ADDENDUM NO. 1 -

Project Name: WBS East Side G Level Concourse Renovation
Project Number: H27-2372
Pre Bid Date & Time: March 20, 2018 at 10:00 AM

WILLIAMS BRICE STADIUM - EAST SIDE CONCESSION RENOVATION

AD1.0
sheet ___ of ___

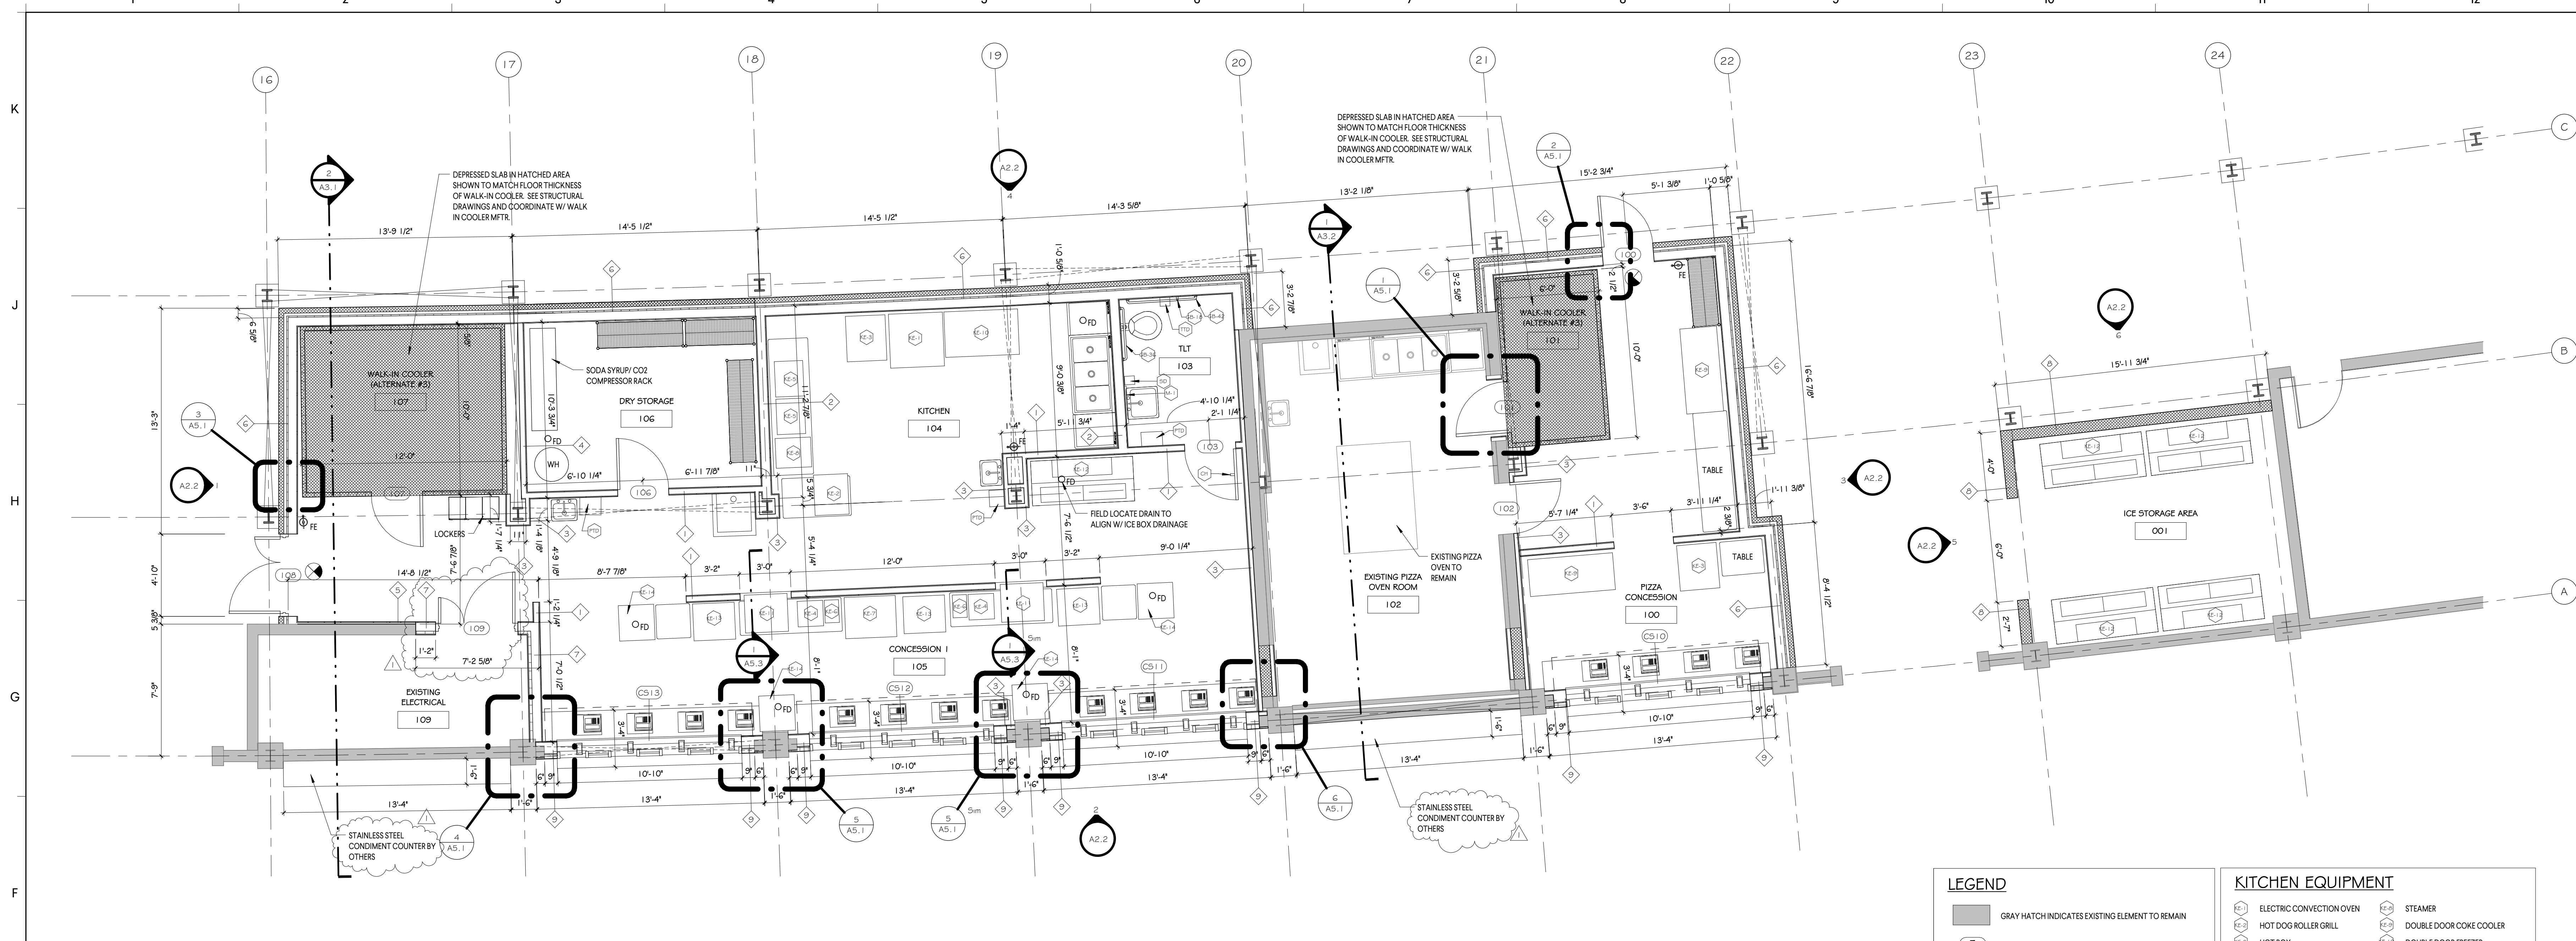
1. Sheet AD1.0, A1.1, A1.2, A5.2, A6.1, A6.2 – **Replace with attached and note clouded revisions.**
2. Sheet S1.0 – **Replace with attached and note clouded revisions.**
3. Sheet ED1.0, E0.3, E0.4, E1.0, E1.1, E1.2, E1.3 – **Replace with attached and note clouded revisions.**
4. Sheet E0.2 – Lighting Fixture Schedule: **The following items are acceptable pre-approved fixtures submitted via substitution request:**

S1.0

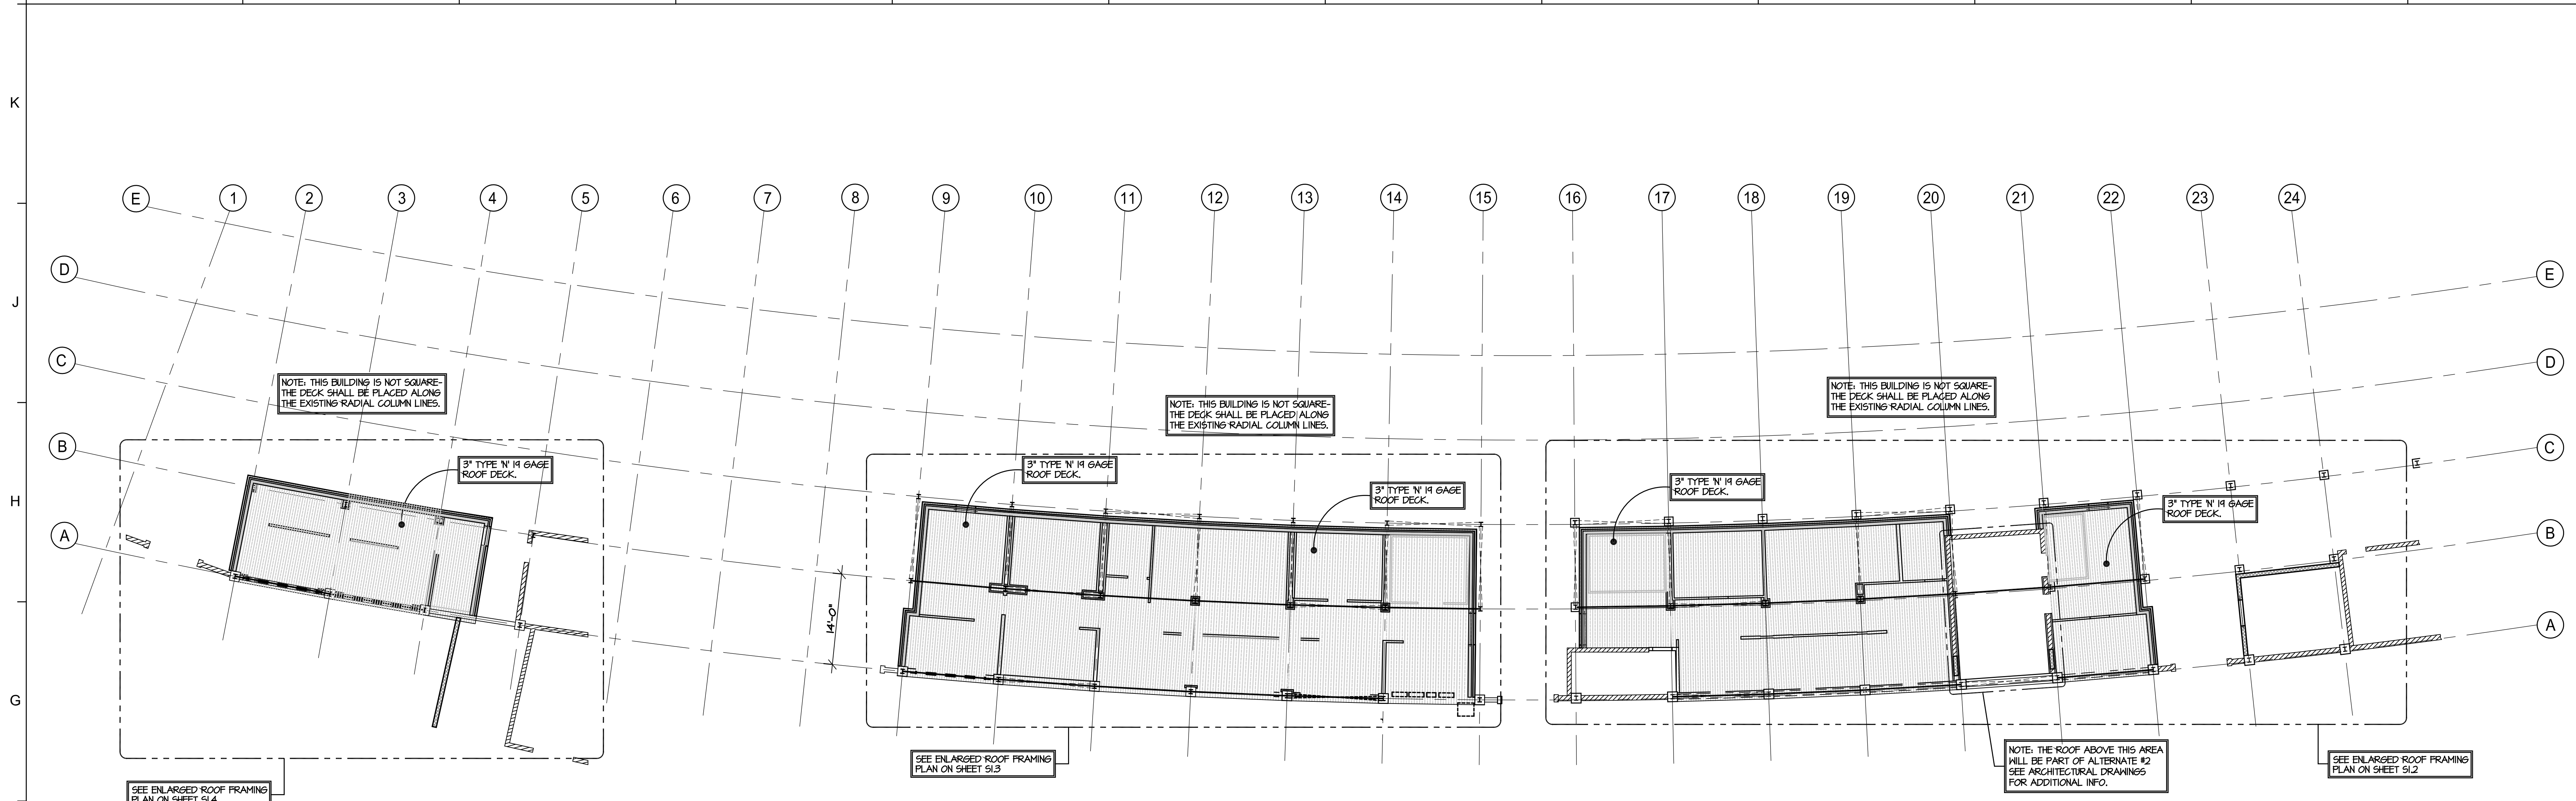
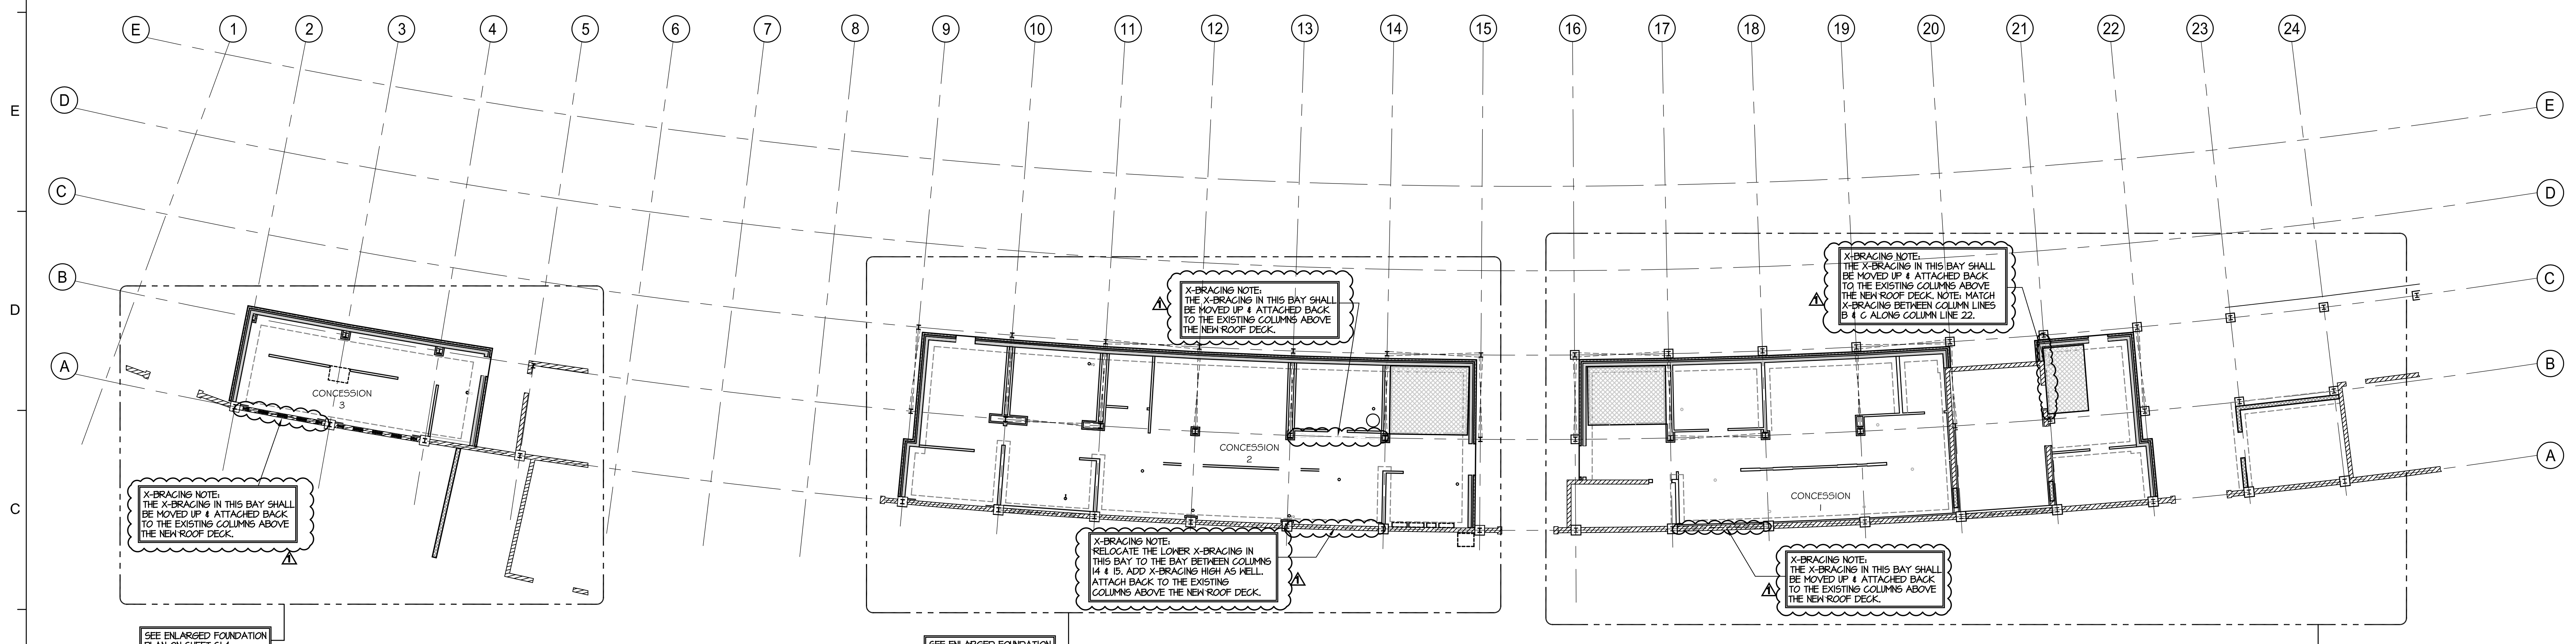
X-BRACING NOTE:
THERE IS EXISTING X-BRACING THAT WILL NEED TO BE REMOVED AND/OR RELOCATED BASED ON FIELD CONDITIONS. NOTIFY E.O.R. PRIOR TO REMOVAL. CONTRACTOR SHALL MAKE AN APPROPRIATE ALLOWANCE FOR X-BRACING REMOVAL AND/OR REPLACEMENT.
